GRADING AND EROSION CONTROL PLANS FOR WALDEN SANITATION DISTRICT WASTEWATER TREATMENT PLANT PROJECT EL PASO COUNTY, COLORADO MARCH 2026

EPC DPW Stormwater did not fully review the last GEC submission since it was not associated with a stormwater permit. New information provided with this submission has triggered the requirement for an ESQCP, so full comments will be provided at this time. See comment on sheet 12 for additional information.

PCD PROJ. NO. : PPR2538

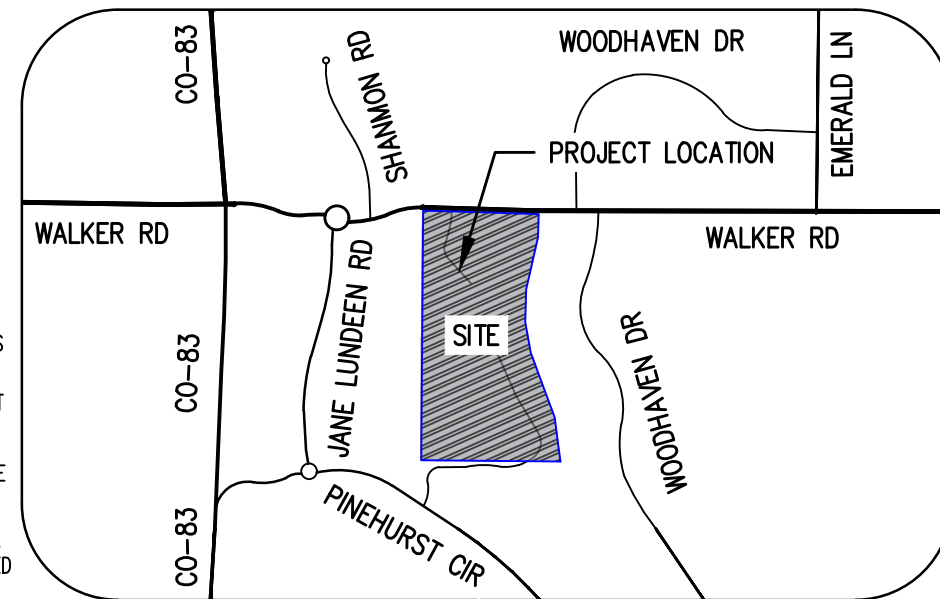
If "limits of disturbance" and "construction boundary" are the same, change to "limits of construction/disturbance" or otherwise show as separate line types for each on the legend and figure.

SHEET TITLE: EROSION CONTROL PLAN I		
PROJECT NUMBER: #3774	SCALE: 1:100	SHEET: C7.1

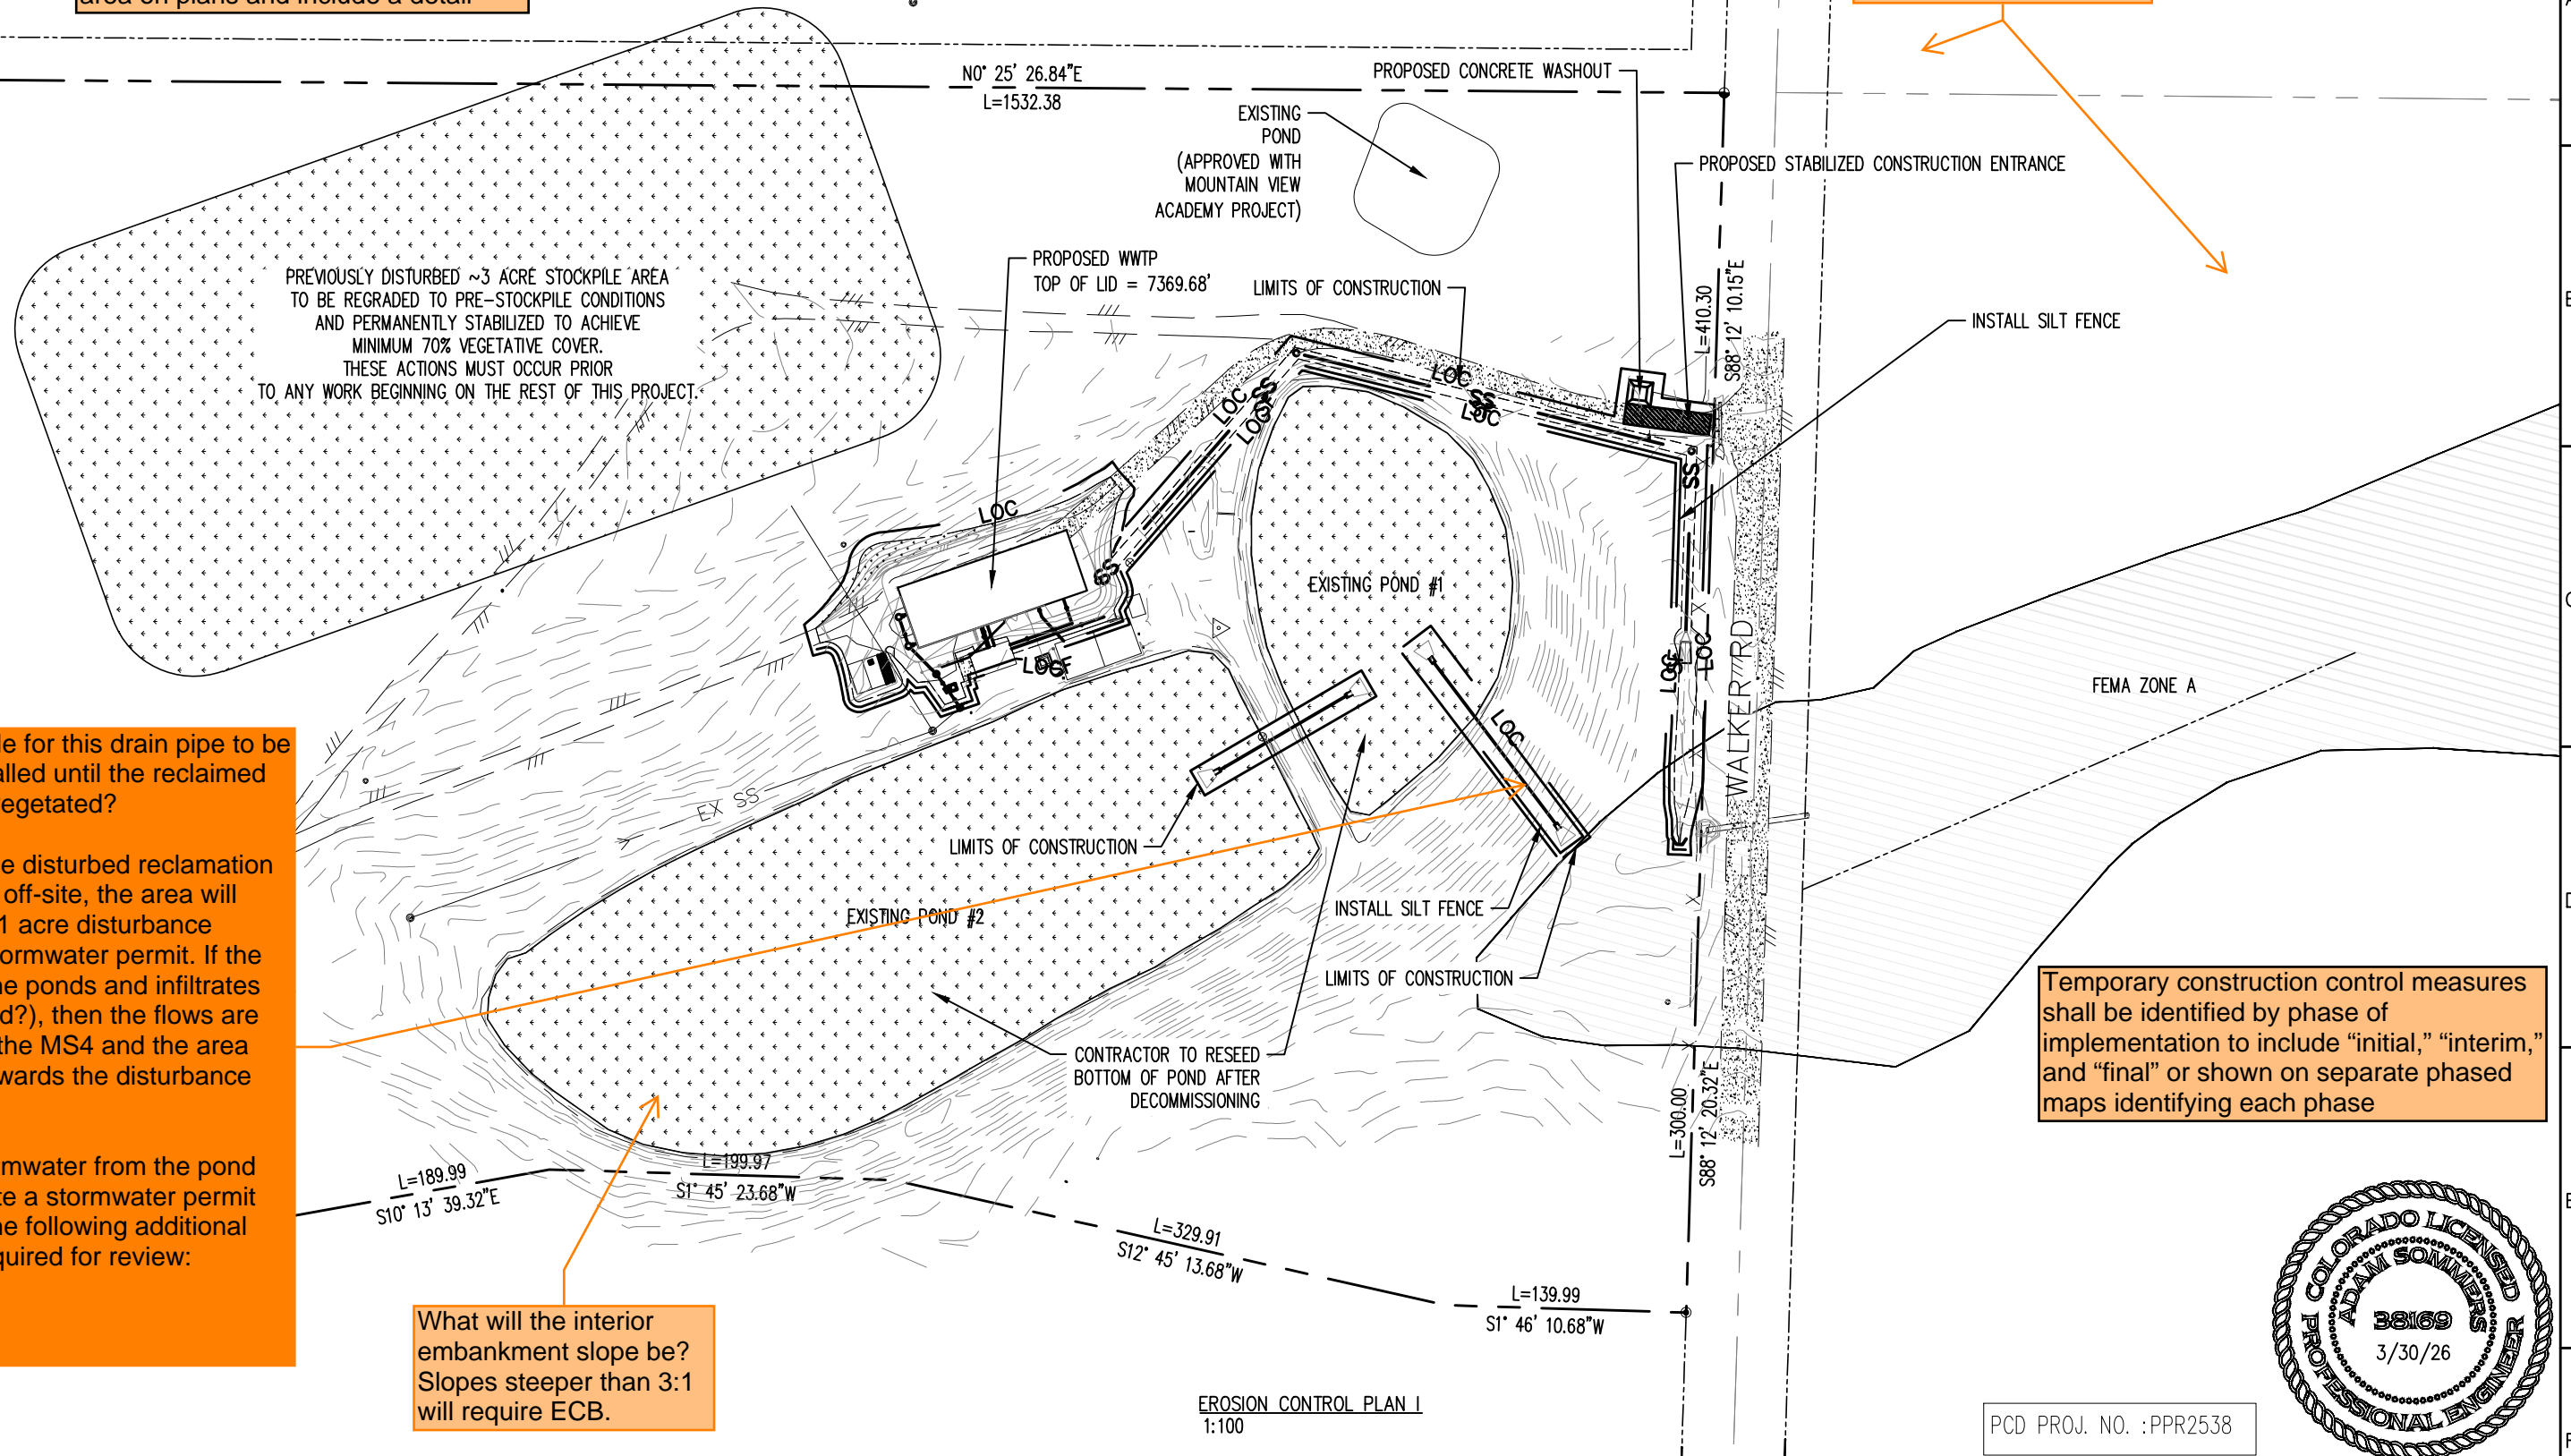
Will there be a staging/storage area for the pond dredging or pipe/equipment? If so, please show area on plans and include a detail

GEC Checklist items M & N. Please provide contour labels and flow arrows

GEC Checklist item C. Provide labels for adjacent property, include parcel numbers

Show areas of cut and fill.

Would it be possible for this drain pipe to be capped or not installed until the reclaimed pond area is fully vegetated?

If the water from the disturbed reclamation area is discharged off-site, the area will count towards the 1 acre disturbance threshold for the stormwater permit. If the water remains in the ponds and infiltrates (are the ponds lined?), then the flows are not discharging to the MS4 and the area would not count towards the disturbance threshold.

Essentially, if stormwater from the pond area leaves the site a stormwater permit will be required. The following additional forms would be required for review:

SHEET TITLE:
 EROSION CONTROL PLAN II
 PROJECT NUMBER: #3774
 SCALE: 1"=40'
 SHEET: C7.2

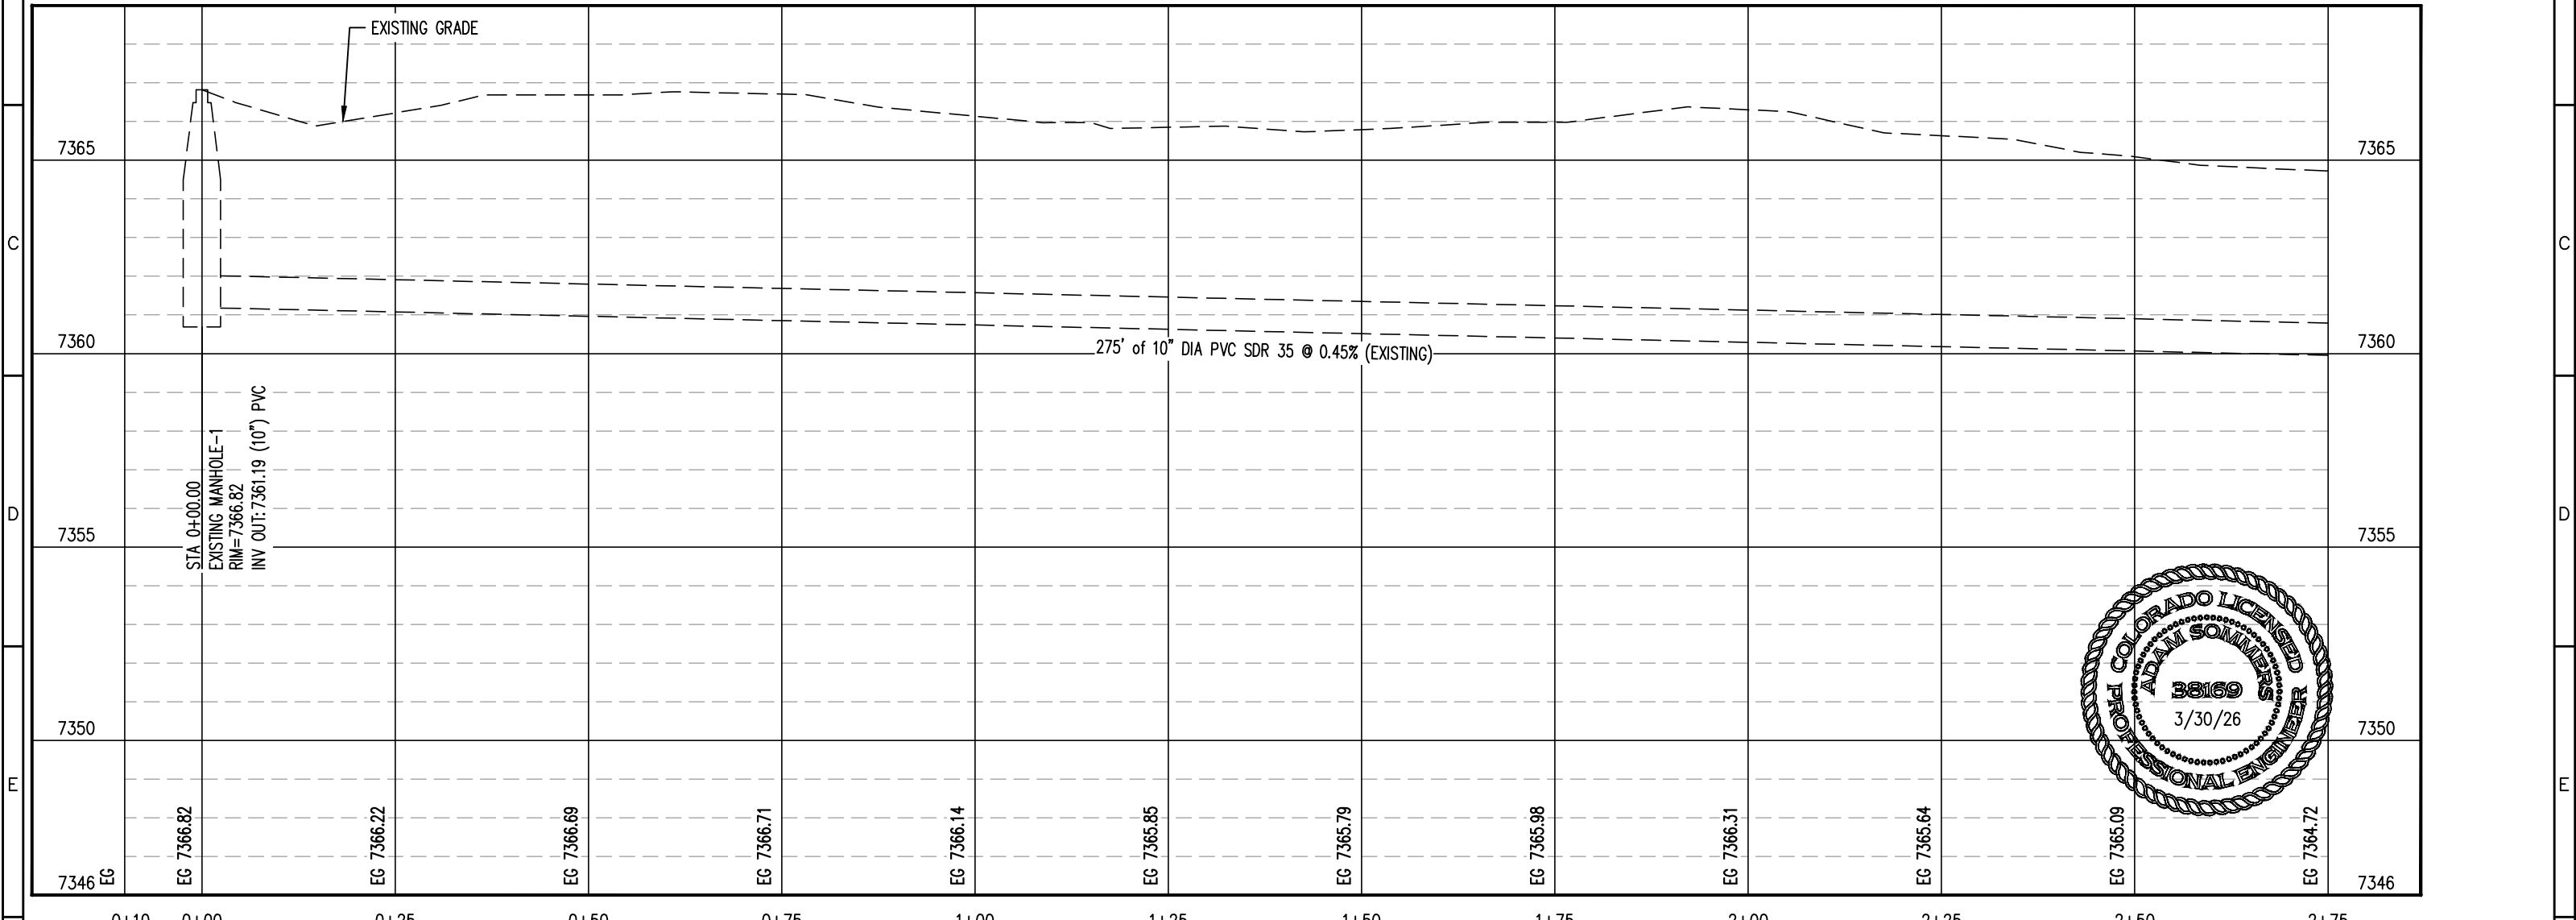
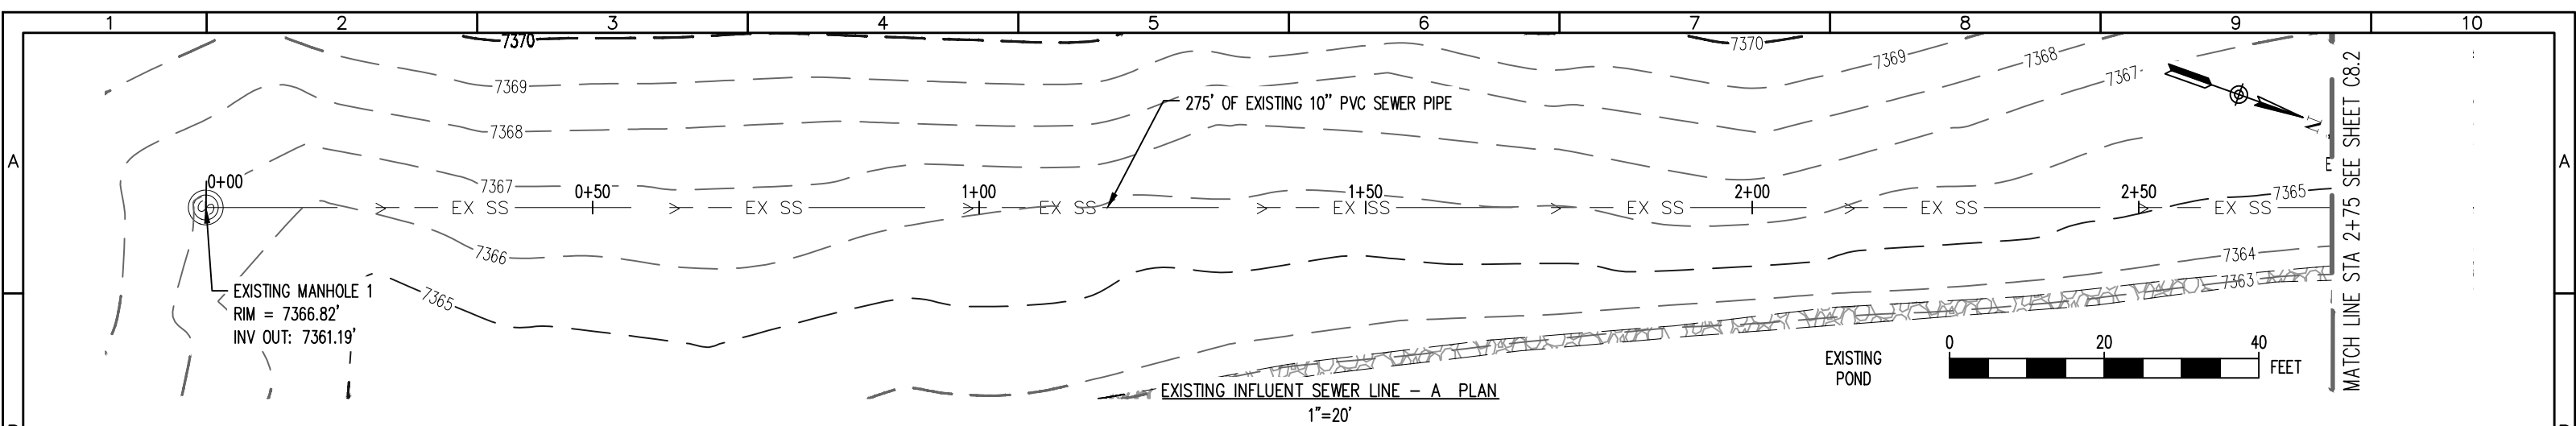
Label pipe size and type on this sheet
